Project	<b>IEEE 802.16 Broadband Wireless Access Working Group</b> < <a href="http://ieee802.org/16">http://ieee802.org/16</a> >	
Title	Soft Handover and Fast BS Switching Procedure	
Date Submitted	<b>2004-07-08</b>	
Source(s)	Hang Zhang, Mo-Han Fong, Jianglei Ma, Peiying Zhu, Wen Tong Nortel Networks	<a href="mailto:mhfong@nortelnetworks.com">mhfong@nortelnetworks.com</a>
	Itzik Kitroser, Yigal Leiba, Yossi Segal, Zion Hadad Runcom Technologies	<a href="mailto:itzikk@runcom.co.il">itzikk@runcom.co.il</a>
	Sohyun Kim, Changhoi Koo, Jaewon Cho, Seung Joo Maeng, Myung-Kwang Byun, Jungwon Kim Samsung Electronics	<a href="mailto:binde.kim@samsung">binde.kim@samsung</a>
	Mary Chion, Jing Wang ZTE	<a href="mailto:mchion@ztesandiego.com">mchion@ztesandiego.com</a>
	Min-Sung Kim KT	<a href="mailto:cyberk@kt.co.kr">cyberk@kt.co.kr</a>
	Donnie Dongkie Lee SK Telecom	<a href="mailto:galahad@nate.com">galahad@nate.com</a>

Re:	IEEE P802.16e/D3-2004	
Abstract	In this contribution, the soft handover and fast BS switching mechanism is proposed	
Purpose	Review and Adopt the suggested changes into P802.16e/D3	
Notice	This document has been prepared to assist IEEE 802.16. It is offered as a basis fo

Figure E.12—Example Soft HO (Active BS set Update: Add)

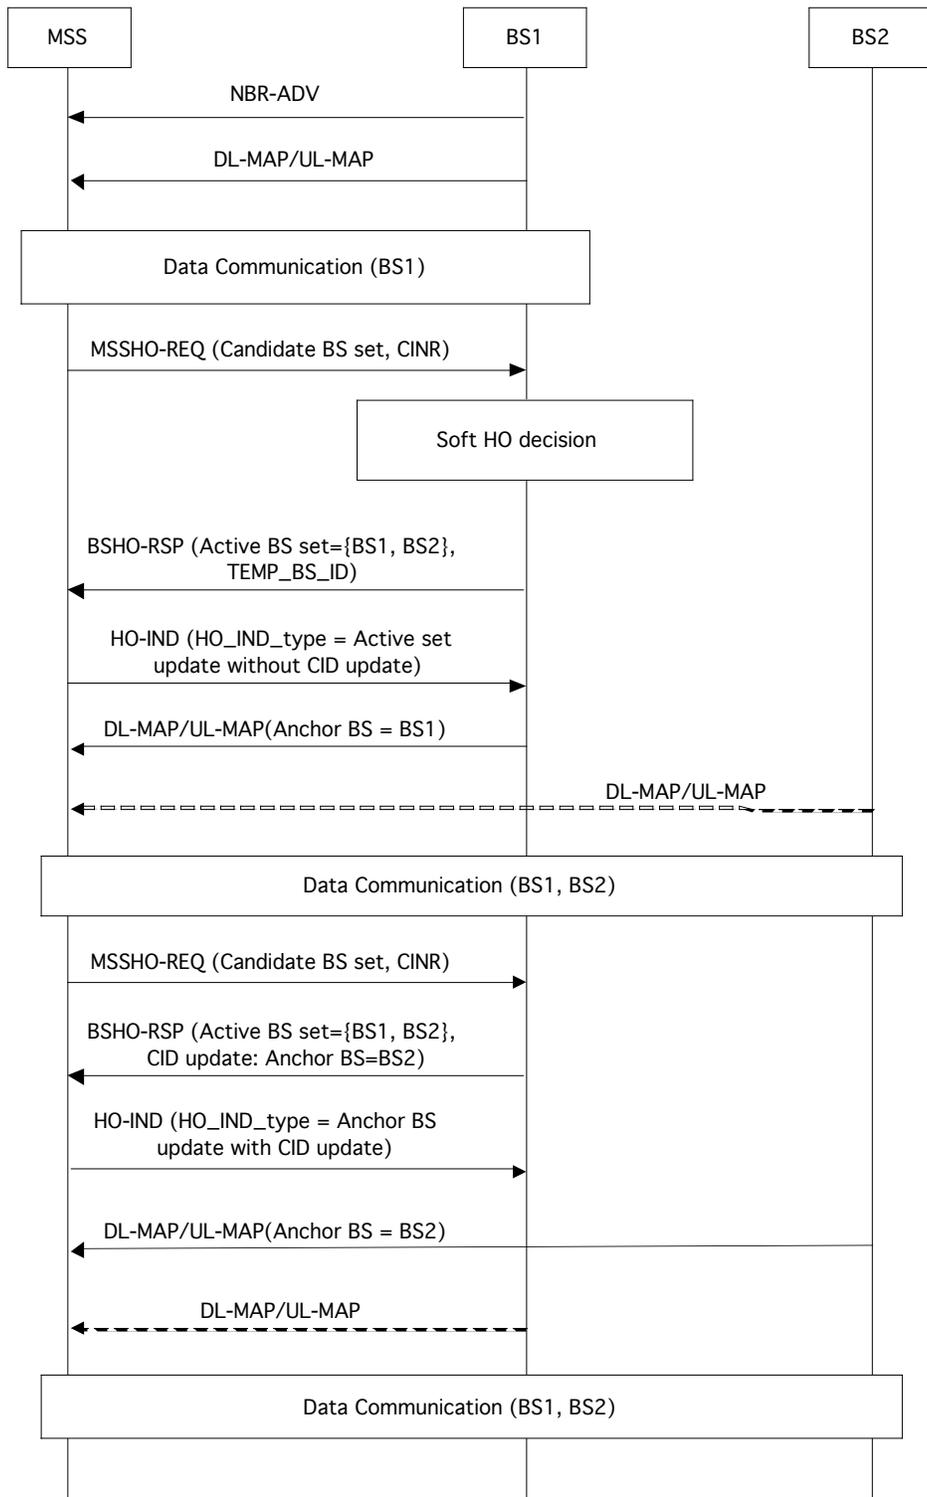
[Add the following call flows to Appendix E]
